Ref: PC/04/14 Proposed Development by Council - Greenway Cornelscourt to Cherrywood

I am writing on behalf of the Dublin Cycling Campaign (who operate through all Local Authorities in Dublin County) in support of the proposed Greenway from Cornelscourt to Cherrywood, which is currently open for public consultation.

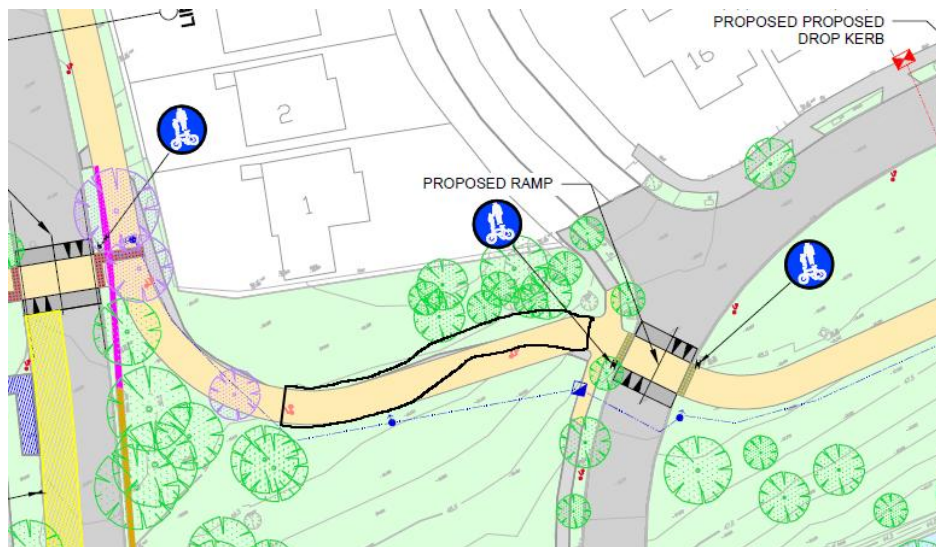
8. Surface markings needed to remind pedestrians of the presence of cyclists.

This is essential for reducing pedestrian/cycle collisions. A roundel marking, similar to sketch below, and as used for South Dublin County Council schemes, is suggested.

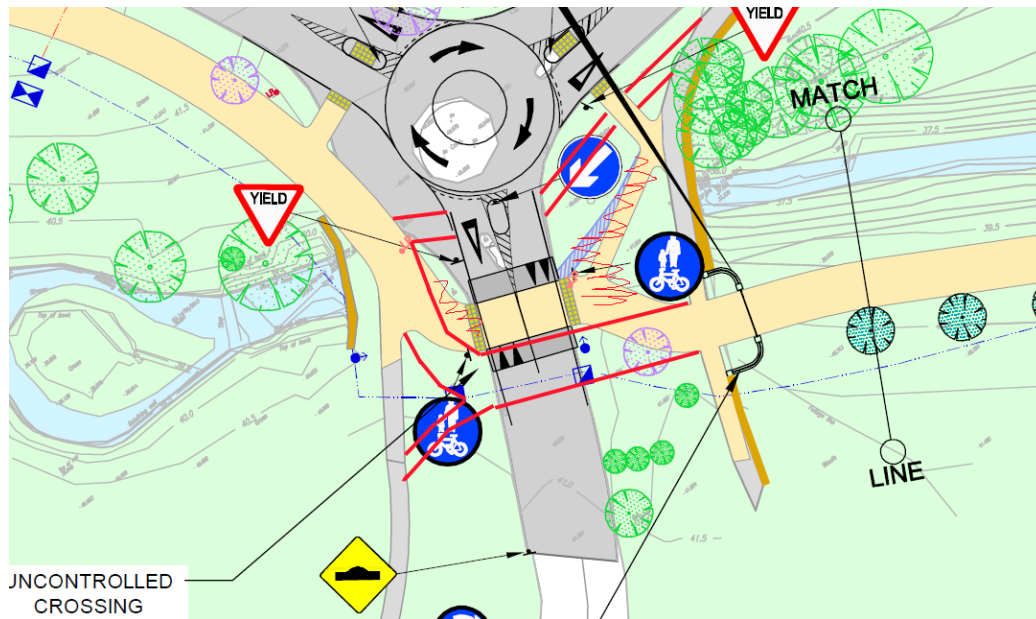
12. Ramped crossings should have alternative surfacing colour.

This would create greater visual impact and mark out the greenway crossing as being different from the road.

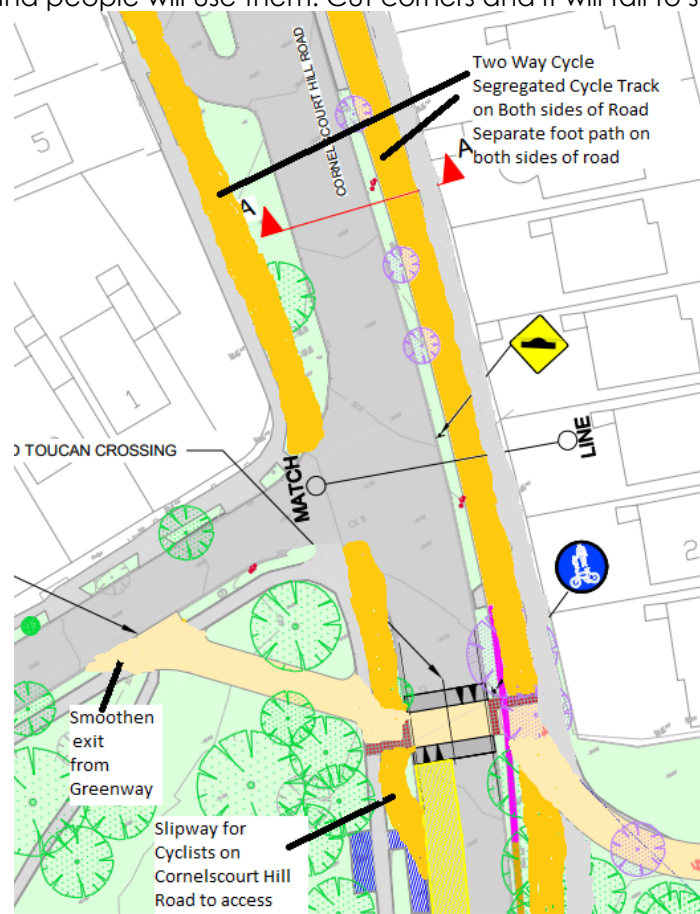
15. Avoid Sharp Bends

The design of the greenway should avoid sharp bends as these pose dangers to both cyclists and pedestrians. On the recently constructed UCD to Luas cycle route, for example, at the redesigned Toucan crossing on the Dundrum road, a steep wall exists beside the entrance to the shared path on the east side of the road. This makes it dangerous for pedestrians as they cannot see cyclists coming on the cycle route. It is also dangerous for cyclists as they cannot see northbound traffic on the Dundrum Road or pedestrians on the footpath until immediately before the Toucan crossing. Such dangerous designs must be avoided in the future.
